Maules Creek Coal Mine

Employee Transport Modification Responses to Submissions

AUGUST 2016
Project No. WHC-15-30
Document No. 00756930.docx

Plate 1 – Western Offsets Figure in approved Revised Biodiversity Offset Strategy (Whitehaven, 2015)

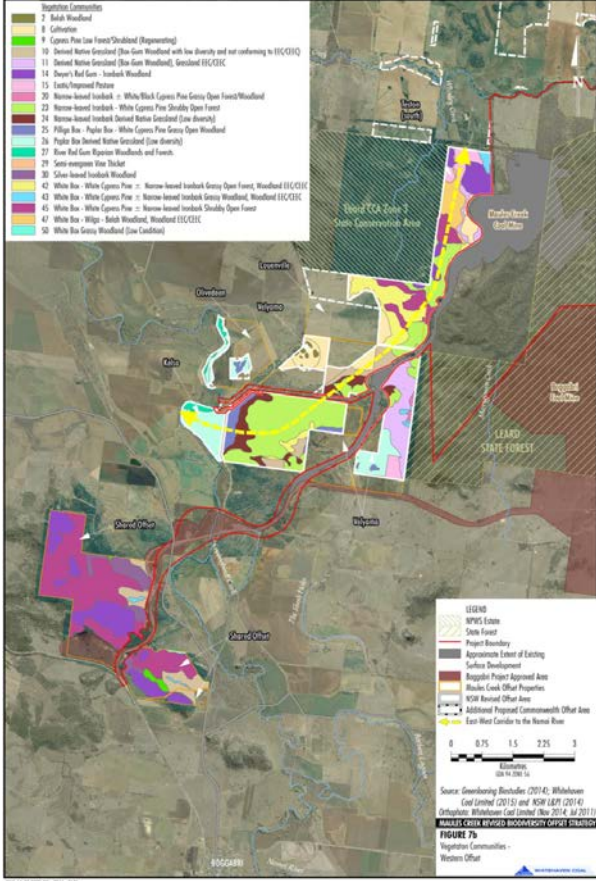
Issue ID Number	Subject	Issue Raised	Response
1	Legislative Requirements	Concern was raised regarding whether Section 79C of the EP&A Act is appropriately addressed in the Modification.	Although Part 3A of the EP&A Act was repealed on 11 October 2011, the Maules Creek Coal Project remains a “transitional Part 3A project” under Schedule 6A of the EP&A Act. The proposed Modification is therefore being considered under Section 75W of the EP&A Act, in accordance with the relevant savings provisions.
2	Proposed Wording Of Condition 63	Concerned was raised regarding the proposed revised wording of Condition 63.	This is addressed in Section 2.1.
3	Biodiversity	Concern was raised regarding the potential for the Modification to impact on previously identified biodiversity corridors. In particular, these submissions suggest that the Modification would increase road transport movements which would in turn result in additional incidents of vehicular fauna strike along the Maules Creek Coal Mine access road. The issues raised include discussion of the Maules Creek Coal Mine access road traversing an east-west biodiversity corridor, leading to potential for vehicular fauna strike.	It should be noted that the approved <i>MCCM Revised NSW Biodiversity Offset Strategy</i> (Whitehaven, 2015) (endorsed by OEH) identified that the east-west biodiversity corridor is located to the west of the Maules Creek access road; hence it is an incorrect assertion that the access road traverses the approved east-west biodiversity corridor (Plate 1).

Issue ID Number	Subject	Issue Raised	Response
3	Biodiversity		 Vegetation Communities 1. Bush Woodland 2. Callitriche 3. Capeweed Pine (see Forest/Shrubland) (Regeneration) 4. Disturbed Native Grassland (See Grass Woodland) with low diversity and not conforming to HSCCH 5. Disturbed Native Grassland (See Grass Woodland), Grassland HSCCH 6. Dyer's Red Gum - Jarrah Woodland 7. Exotic/Invasive Plantation 8. Native Jarrah Woodland 9. Native Jarrah Woodland - White/Black Capeweed Pine Grass Open Forest/Woodland 10. Native Jarrah Woodland - White Capeweed Pine Shrubby Open Forest 11. Native Jarrah Woodland Disturbed Native Grassland (See diversity) 12. Pilgah Pine - Pilgah Pine - White Capeweed Pine Grass Open Forest/Woodland 13. Pilgah Pine Disturbed Native Grassland (See diversity) 14. River Red Gum Riparian Woodlands and Forests 15. Semi-deciduous Pine Shrub 16. Silver Jarrah Woodland 17. White Box - White Capeweed Pine - Native Jarrah Woodland Grass Open Forest, Woodland HSCCH 18. White Box - White Capeweed Pine - Native Jarrah Woodland Grass Woodland, Woodland HSCCH 19. White Box - White Capeweed Pine - Native Jarrah Woodland Shrubby Open Forest 20. White Box - Wilga - Jarrah Woodland, Woodland HSCCH 21. White Box Grassland (See Condition) LEGEND - NPWS Estate - State Forest - Project Boundary - Approximate Extent of Existing Surface Development - Requisite Project Approval Area - Requisite Project Approval Area - NSW Revealed Offset Area - Additional Proposed Commonwealth Offset Area - East-West Corridor to the Native River Scale: 0 0.75 1.5 2.25 3 Kilometres Source: Greening Australia (2014); Whitehaven Coal Limited (2015) and NSW LEP (2014) Orthophoto: Whitehaven Coal Limited (New 2014, Jul 2011) MAULES CREEK REVISOR BIODIVERSITY OFFSET STRATEGY FIGURE 7b Vegetation Communities - Western Offset
